Mitsubishi Electric AC Servo System

No.21-22E

UL Certification Withdrawal for Mitsubishi Electric Motor Circuit Breakers and Effect on Combinations with Mitsubishi Electric AC Servos

Table 1. Identification of UL certification marking (MMP-T32 series)

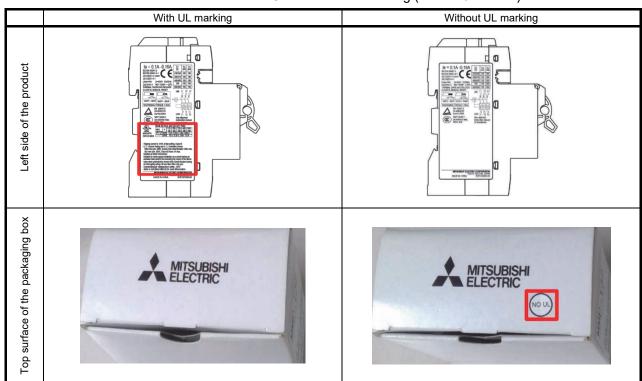
Note that combinations of the MMP-T32 series without UL marking (manufactured in April 2021 or later) and the AC servos do not meet UL requirements.
